SUBJECT: Forwards responses to Reactor Sys Branch questions re steam line break analysis, per NRC 810109 telcon request. Info will be incorporated into FSAR & directly distributed as part of Amend 25.

STEAM LINE BREAK ANALYSIS

CONFIRMATORY EVALUATION

San Onofre Nuclear Generating Station

FIGURE 1-1 COMPARISON OF STEAM LINE BREAK REACTIVITIES OBTAINED WITH DIFFERENT TIMES FOR INITIATION OF REACTOR COOLANT PUMP COASTDOWN

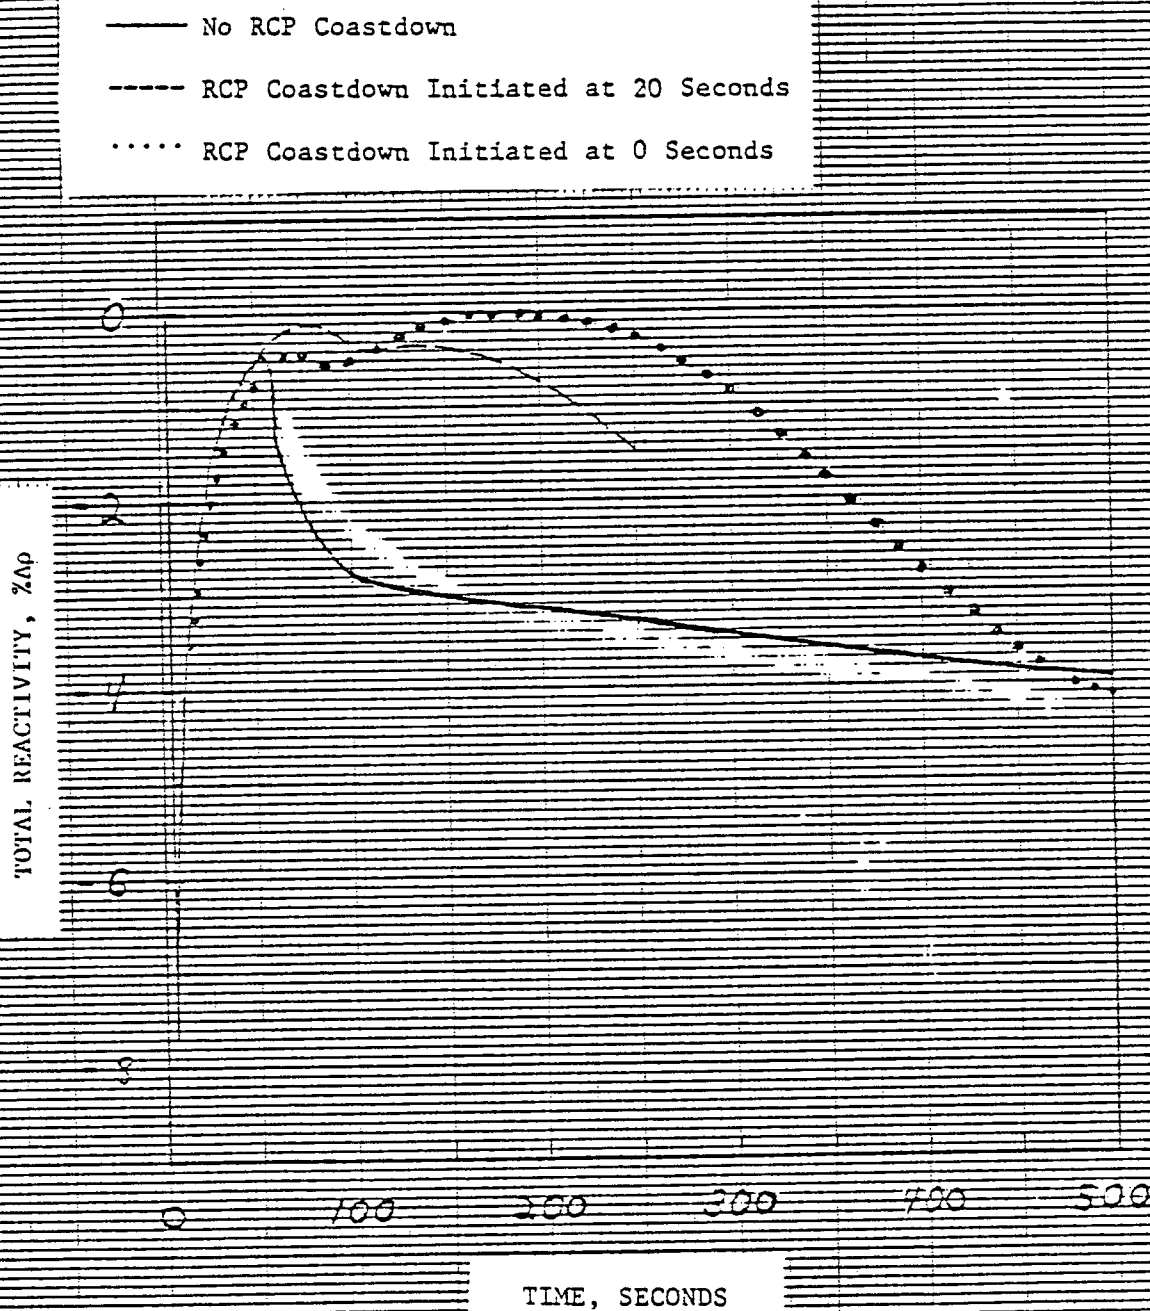
Question 1: Do the steam line break (SLB) analyses presented in the FSAR bound the transient which would result if the operator (following I&E Bulletin 79-06C guidance) tripped the reactor coolant pumps (RCPs) following safety injection actuation signal (SIAS) due to low pressurizer pressure?

The effect of RCP shutoff following SIAS is illustrated for a large SLB initiated at full load conditions by the reactivity and heat flux transients presented in Figures 1-1 and 1-2, respectively. In each figure, the transients presented in the FSAR-- no RCP coastdown (solid line) and RCP coastdown at time zero (dotted line)-- are provided together with the transient (dashed line) resulting from RCP coastdown initiated at the time which causes the maximum post-trip return to power: 20 seconds after initiation of the transient (SIAS occurs at 13 seconds). Figure 1-1 shows that the transient total reactivity is bounded by the case presented in the FSAR: RCP coastdown initiated at time zero. The timing of the reactivity peak causes the maximum post-trip heat flux (Figure 1-2) to be slightly higher for the transient resulting from RCP coastdown initiated at 20 seconds than for either of the cases presented in the FSAR. This difference in post-trip heat flux is not sufficient to alter the conclusions presented in the FSAR.
